PART 21 INTERIM EVALUATION OF A DEVIATION - CONTACTOR FAILURE

Subject:
10CFR Part 21 Notification Report for Size 4 Freedom Series Contactor with
NLI Special Coil

Part 21 Report No: P21-05192016

Figure 1

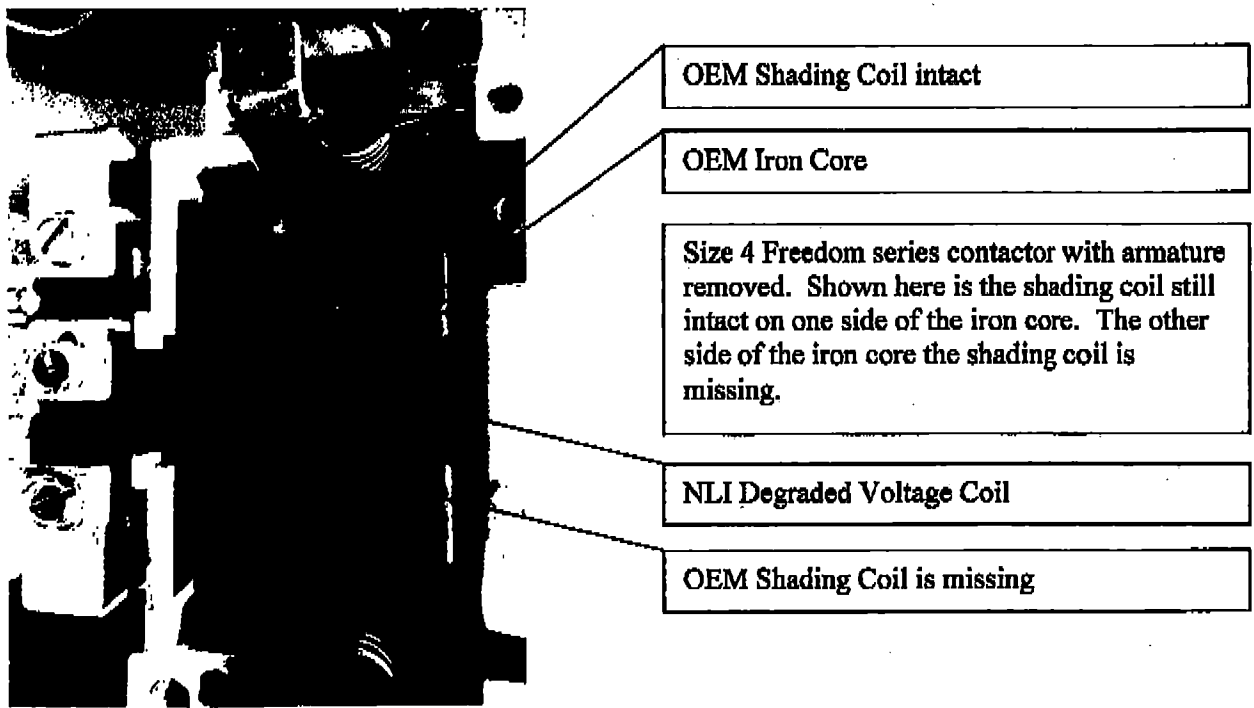
For contactors/starters utilized in continuous duty applications, the OEM shading coils, on the contactor core, shown in Figure 1 below, have the potential to become loose and fall off. If the shading coils are not in the intended location on the core, there is the potential for excessive chatter to occur on the normally open auxiliary contacts that are closed when the contactor is energized.

When the contactor/starters that have the special coil installed are utilized in a continuous duty operation (continuously energized greater than 60 minutes) the special coil reaches a higher temperature than the original manufacturer's coil. The increased heat is potentially causing degradation of the acrylic resin that is utilized by the manufacturer to hold the OEM shading coils onto the OEM core. After the acrylic resin is no longer providing a secure hold on the shading coils, the shading coils can then become loose from the iron core. See the figures 1 and 3 below for identification of the shading coils.

NLI has enhanced the design of the original OEM restraint for the shading coil that can withstand the higher temperatures associated with the NLI special coil.

Figure 2

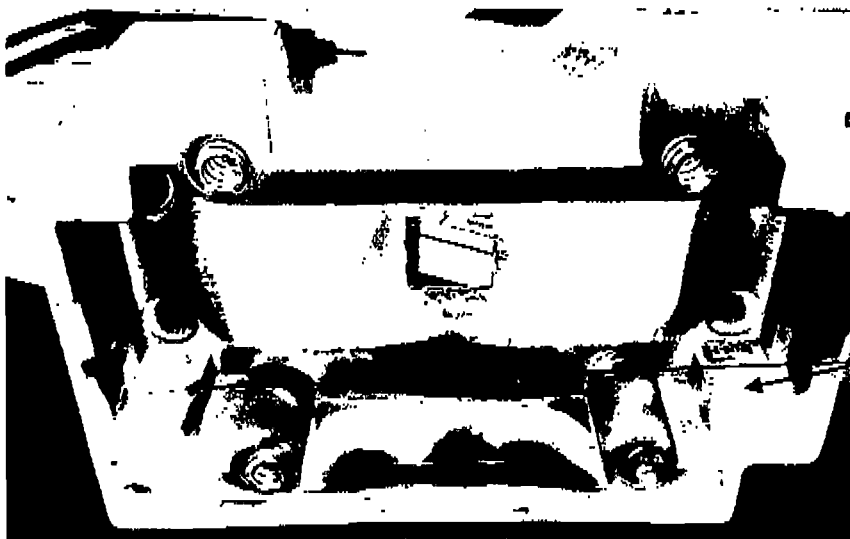
The condition of the shading coils being loose from the core during operation causes a considerable amount of audible noise due to the armature repeatedly coming away from and then being re-magnetized to the core at 120 cycles per second. There is no evidence of any contact chatter on the main contacts. However, there has been recordable contact chatter on the normally open auxiliary contacts that are closed when the contactor is energized. On the size 4 starter, the internals showed evidence of increased wear (See Figure 2 below). If the auxiliary contacts are being used for "seal-in" for the contactor or providing power to an auxiliary relay, there is a potential for the chatter to be significant enough to drop out the contactor or cycle an auxiliary relay. This scenario would only be prevalent if the shading coils are loose from the iron core and the unit is operating without the shading coils in place.

Inside the cover of the Size 4 Freedom series contactor after operating continuously for 35 hours without the shading coils installed. The armature guides were worn and the armature created grooves in the cover.

If the contactors are noticed to be creating an excessive amount of noise >85db when energized, then the unit should be monitored and evaluated to determine if the OEM shading coils have become loose from the unit. If the OEM shading coils have become loose from the iron core, NLI recommends that the qualified modification be performed. If the inside of the contactor case is severely worn, NLI recommends that the unit be replaced.
